| FED.ROAD DIST.NO. | STATE | PROJ. NO. | FISCAL YEAR | SHEET NO. | TOTAL SHEETS |
|---|---|---|---|---|---|
| HAWAII | HAW. | I-H3-1(72) | 1991 | ADD. 60 | 521 |

# GRADING PLAN
## H3 - KANEOHE INTERCHANGE
## STA. 333+62 TO STA. 344+00

# GRADING PLAN
## RAMP D
## STA.1083+57.76 TO STA. 1091+00

# GRADING PLAN
# RELOCATED LIKELIKE HIGHWAY
# STA. 0+00 TO STA. 9+00

# GRADING PLAN
## RELOCATED LIKELIKE HIGHWAY
## STA. 45+00 TO STA. 52+00

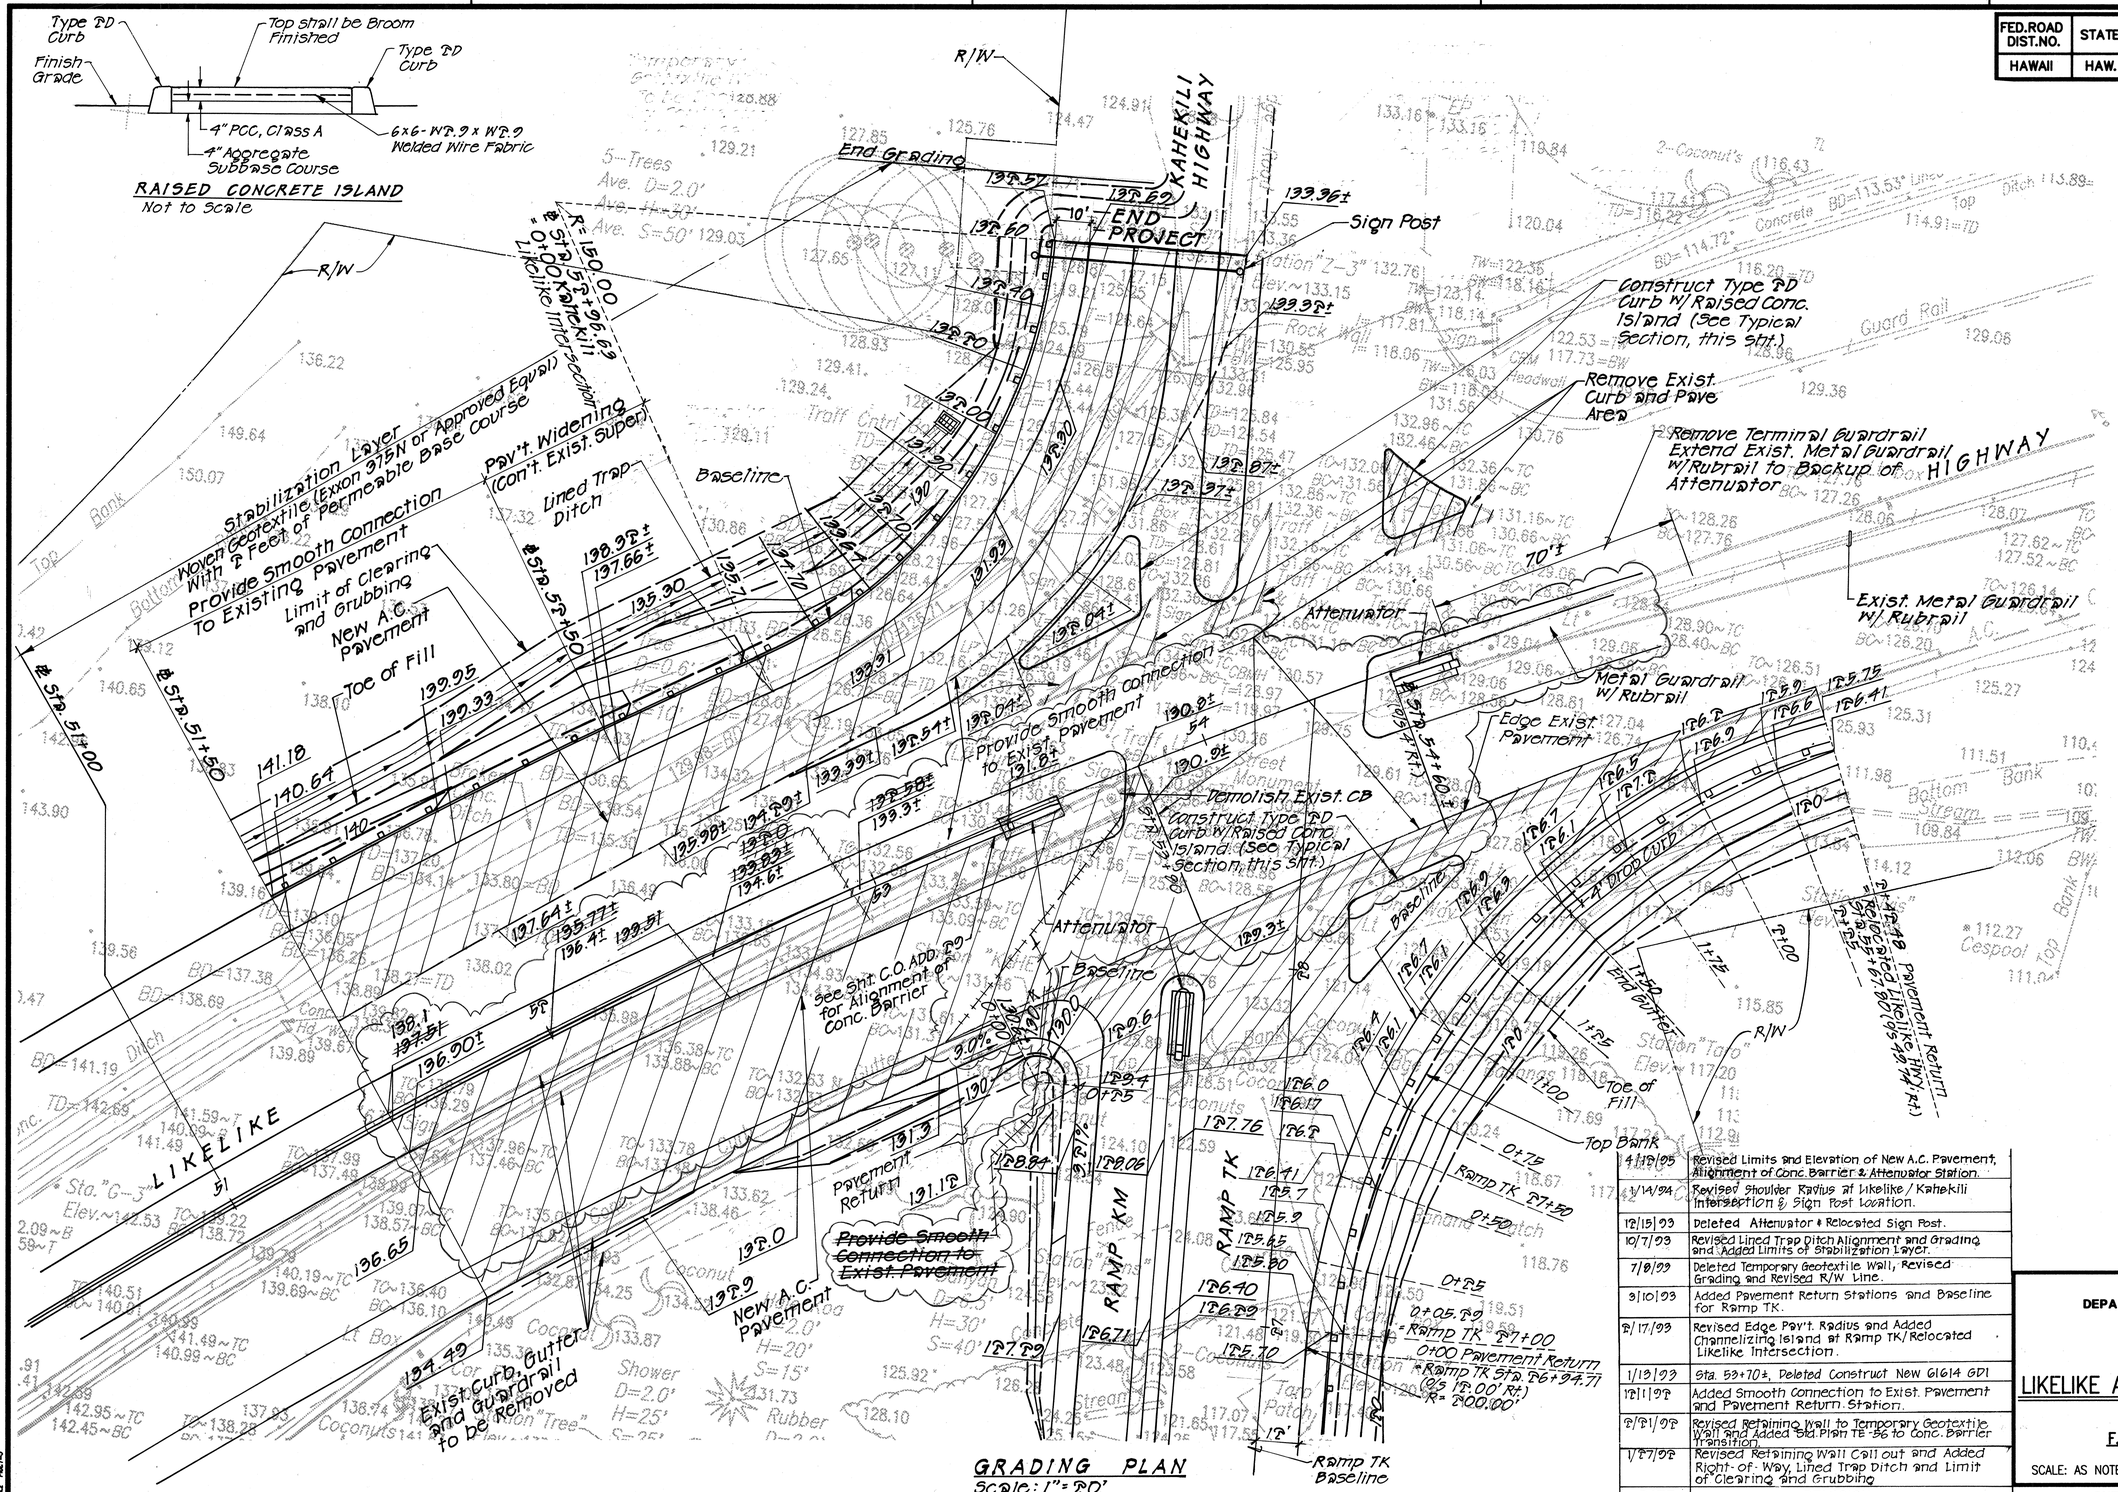
| DATE | REVISION |
|---|---|
| 4/4/95 | Revised Baseline Elevation @ Sta. 51+50. |
| 1/27/92 | Revised Limits of Clearing and Grubbing. |

# GRADING PLAN
# RAMP TK
## STA. 0+00 TO STA. 11+00

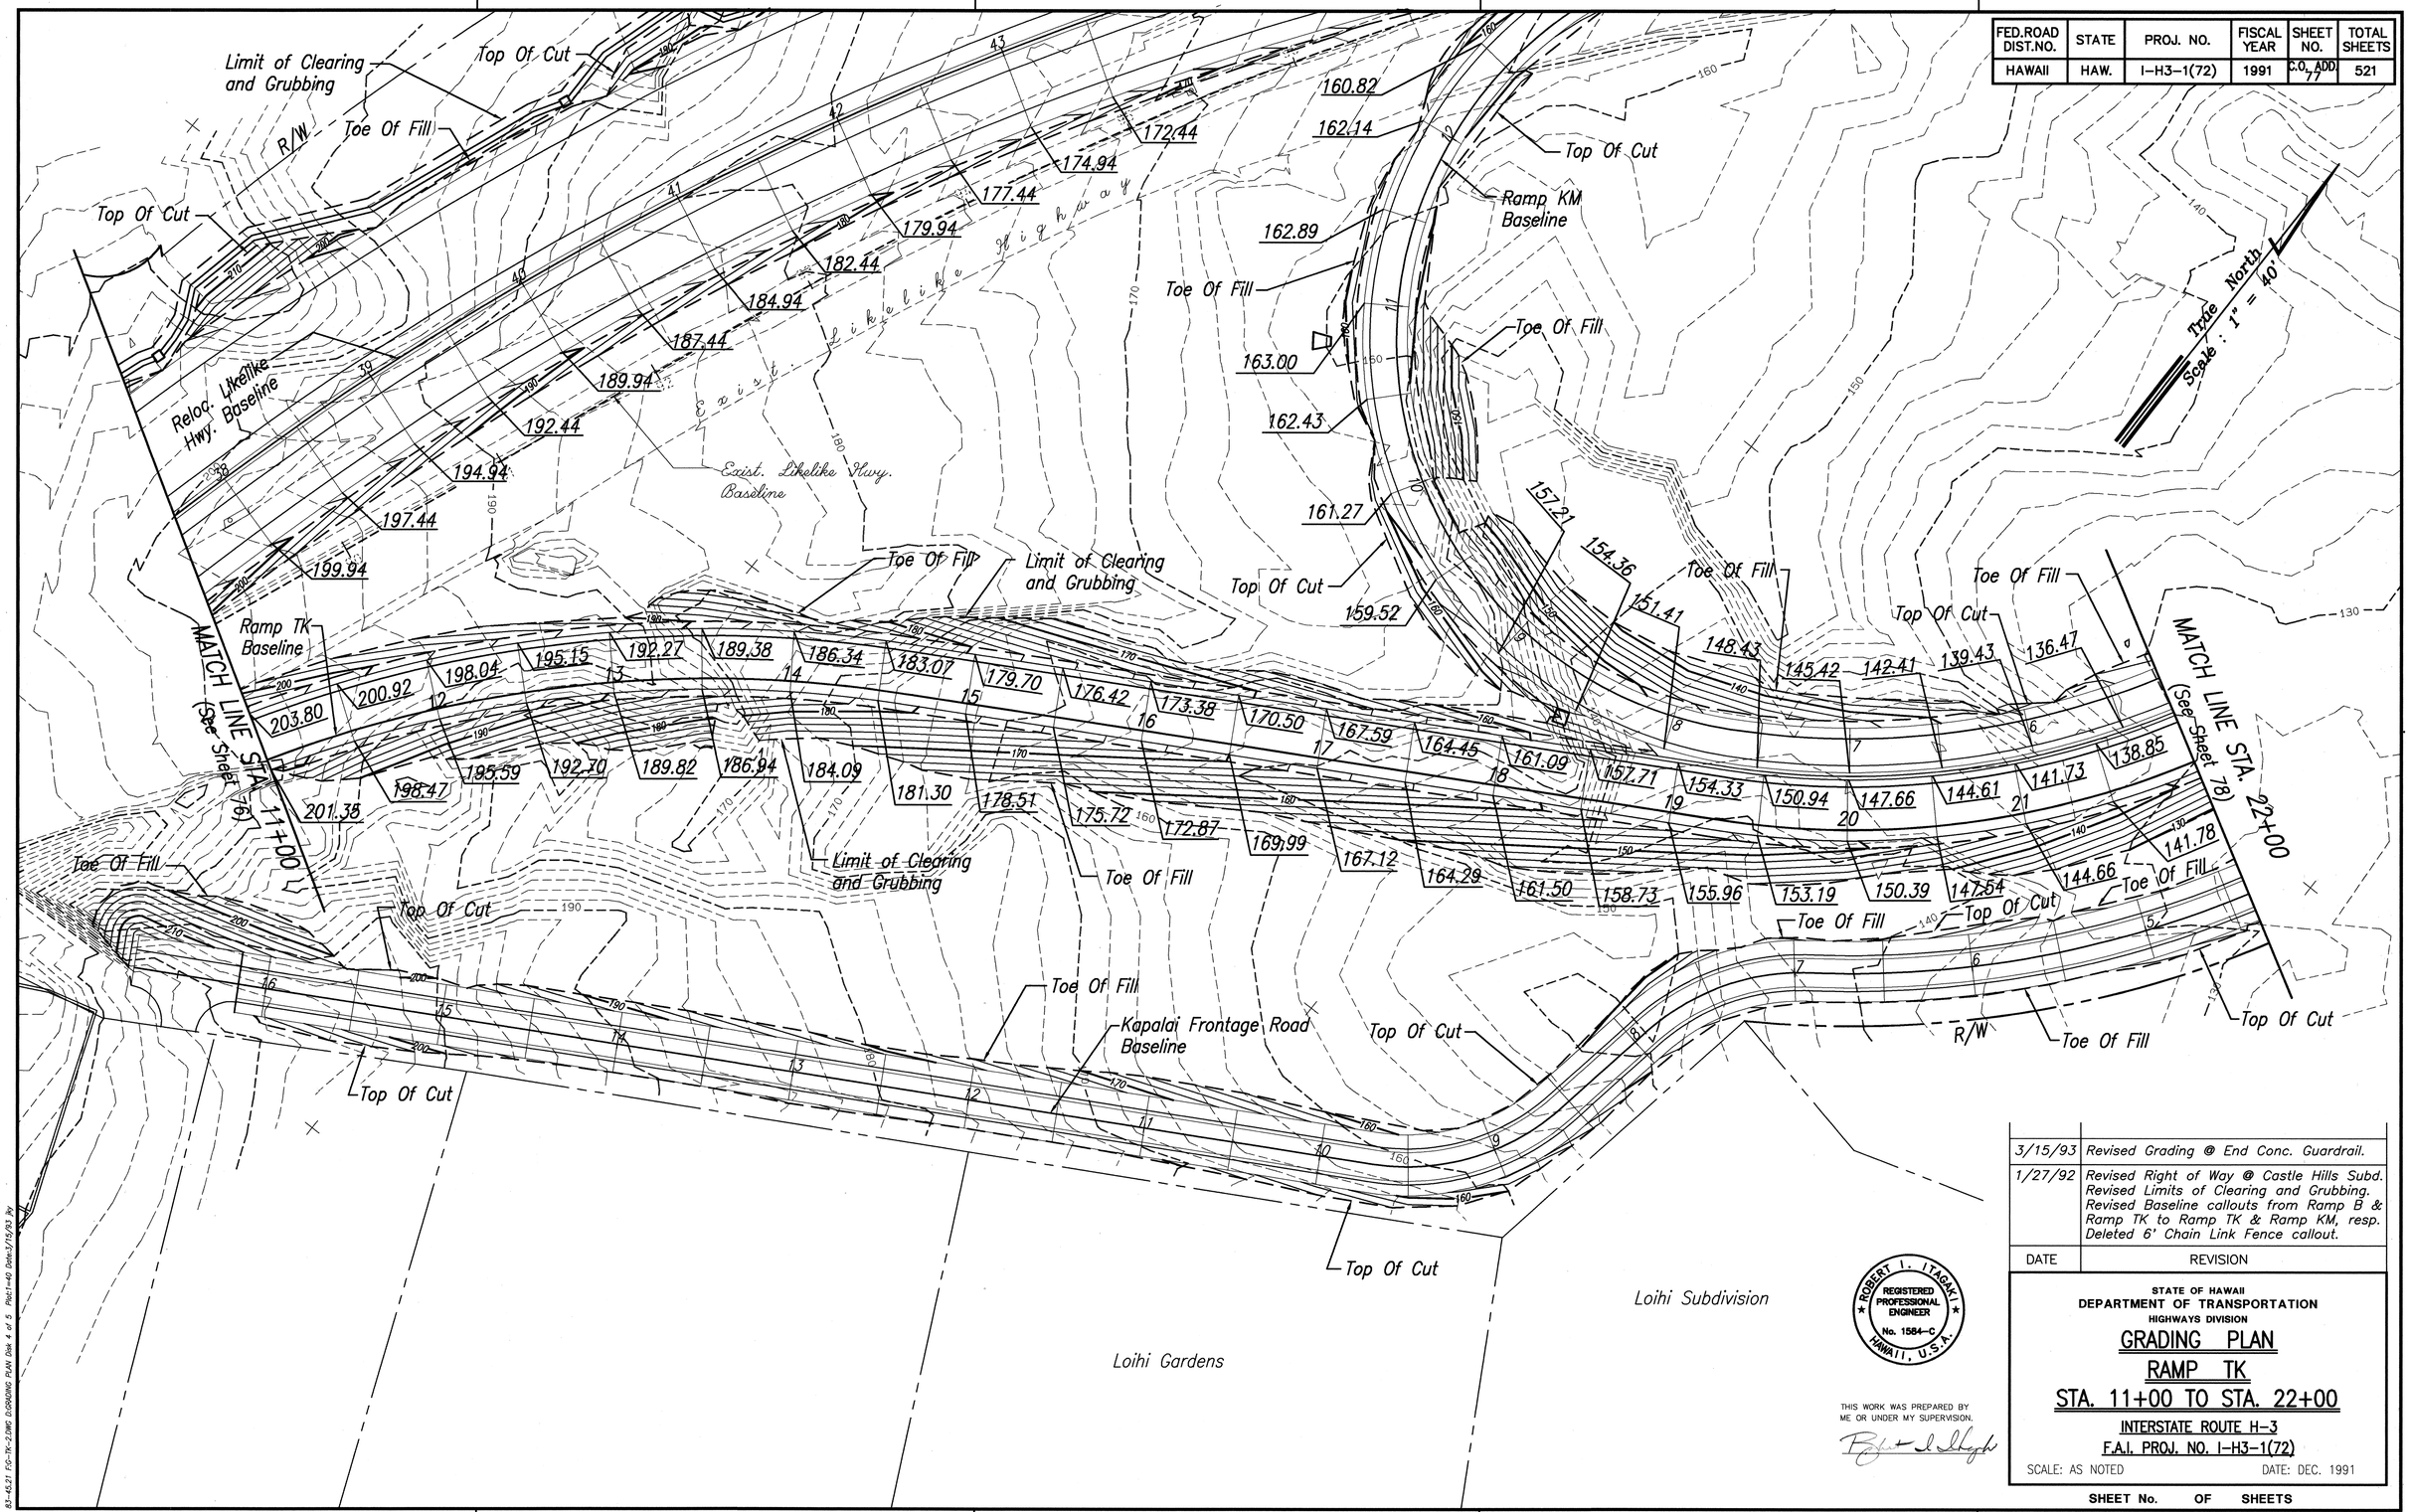
| 7/2/93 | Revised Likelike E.E.R. Grading. |
| 3/29/93 | Revised grading @ TK Station 1+90± & ℄ Sta. 33+00 to 36+00 |
| 1/27/92 | Revised Right of Way @ Castle Hills Subd. Revised Limits of Clearing and Grubbing. |

# GRADING PLAN
## RAMP TK
## STA. 11+00 TO STA. 22+00

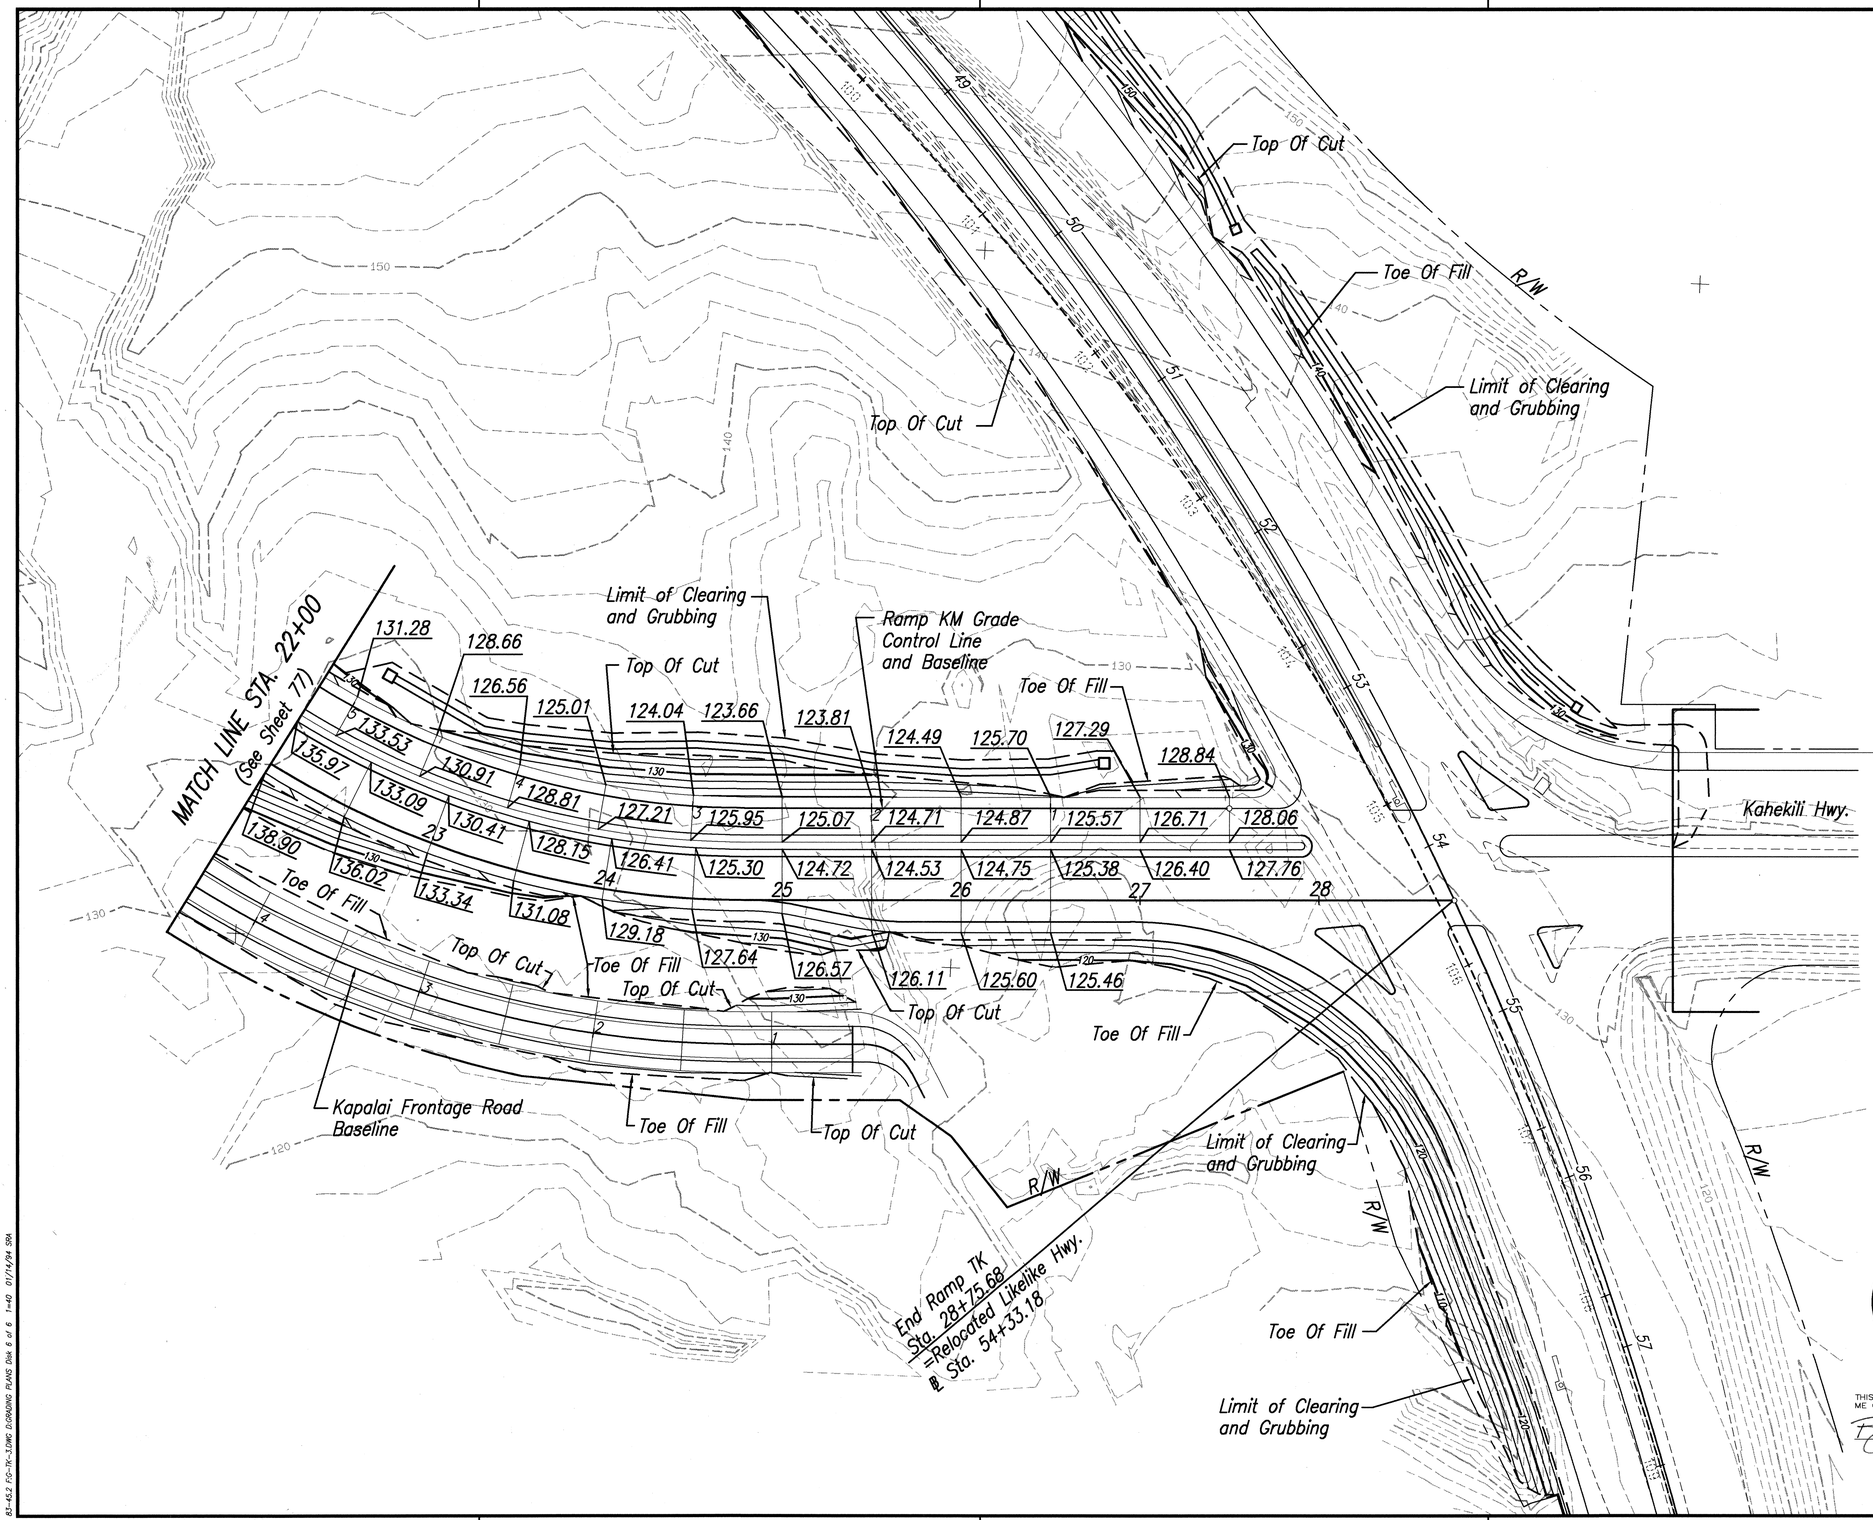
| DATE | REVISION |
|---|---|
| 3/15/93 | Revised Grading @ End Conc. Guardrail. |
| 1/27/92 | Revised Right of Way @ Castle Hills Subd. Revised Limits of Clearing and Grubbing. Revised Baseline callouts from Ramp B & Ramp TK to Ramp TK & Ramp KM, resp. Deleted 6' Chain Link Fence callout. |
